Project	IEEE 802.16 Broadband Wireless Access Working Group < http://ieee802.org/16 >		
Title	Auth FSM		
Date Submitted	2007-02-16		
Source(s)	Avishay Shruga	Intel corporation	voice: +972-3-920-5763
	Phillip Barber	Huawei	avishay.shruga@intel.com
	Joseph Schumacher	Motorola	
	Tricci So	Nortel	
	Modified by		Tel: +82-31-279-5748
	Kyeong-Tae Do	Samsung	kyeongtae.do@samsung.com
	Wonil Roh	Samsung	chosh@etri.re.kr
	Seokheon Cho	ETRI	poong2@posdata.co.kr
	Sungho Yoo	PosData	ksryu@lge.com
	Kiseon Ryu	LG	
Re:	IEEE Std 802.16-2004/Cor2/D2		
Abstract	The contribution defines the Authorization FSM for PKMv2 EAP only authentication. Including States, Events and Transitions		
Purpose	Resolve ambiguity in definition of Auth FSM		
Notice	This document has been prepared to assist IEEE 802.16. It is offered as a basis for discussion and is not binding on the contributing individual(s) or organization(s). The material in this document is subject to change in form and content after further study. The contributor(s) reserve(s) the right to add, amend or withdraw material contained herein.

Single EAP Authorization FSM

Intel Corporation, modified by Samsung

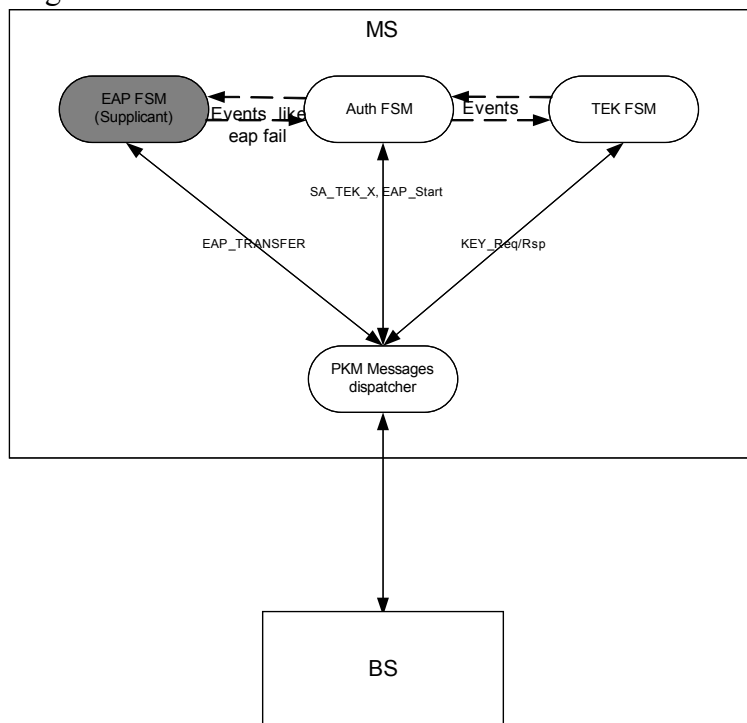
The relationships between the security-related FSMs in the system are as described in the diagram:

Figure 131a – Authentication State Machine for PKMv2 single EAP

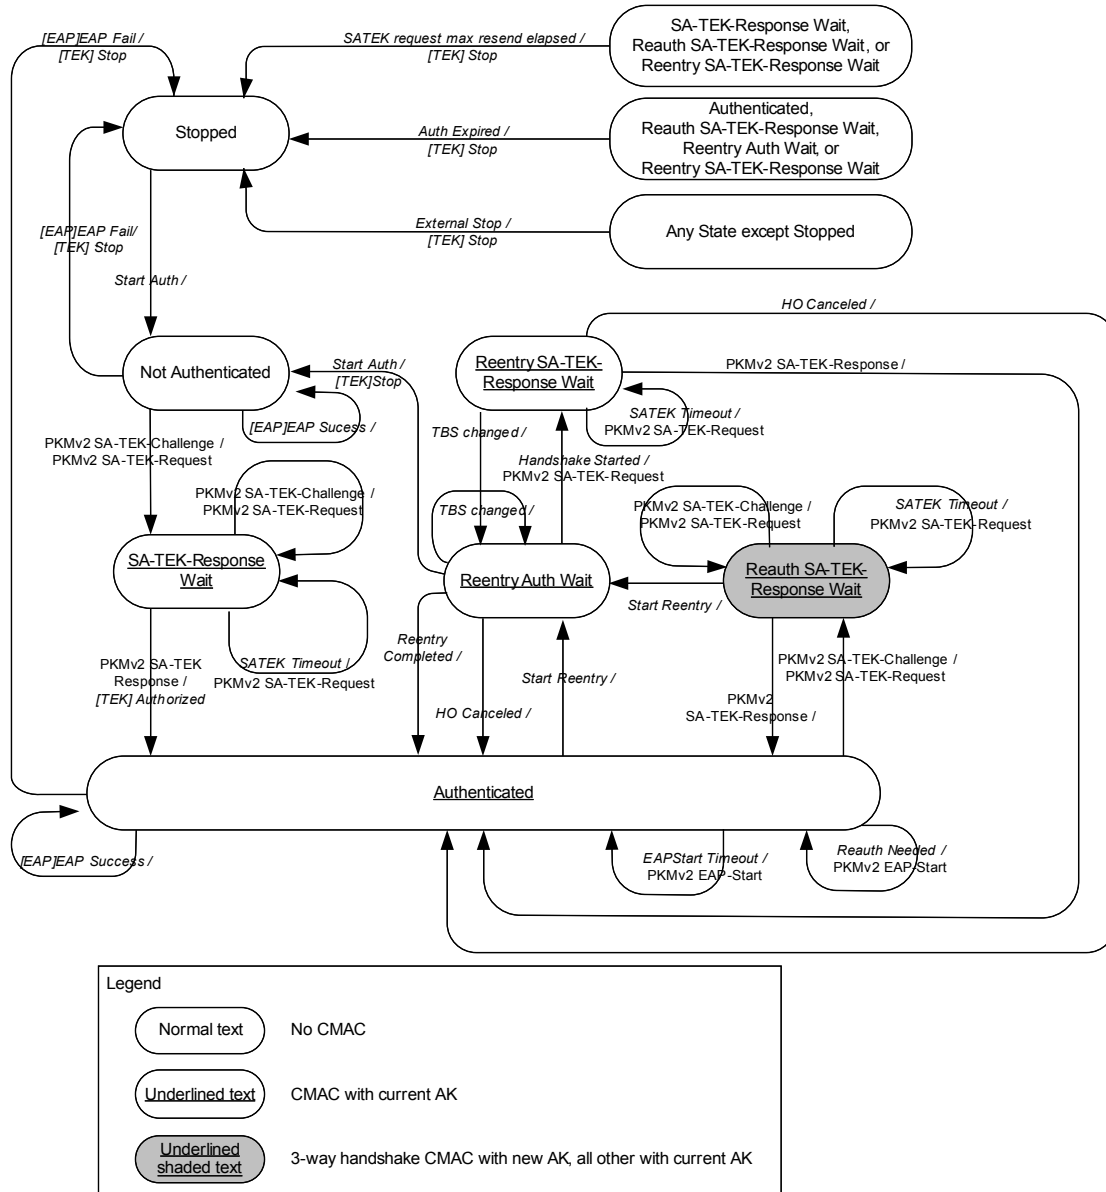
[Add the following text to page 179 below Table 133d of P80216-Cor2_D2]

7.2.2.5 Authorization state machine

The Authentication state machine for single EAP authentication consists of six states and sixteen events (including receipt of messages and events from other FSMs) that may trigger state transitions. The Authentication state machine is presented in both a state flow diagram (Figure XXX) and a state transition matrix (Table XXX). The state transition matrix shall be used as the definitive specification of protocol actions associated with each state transition.
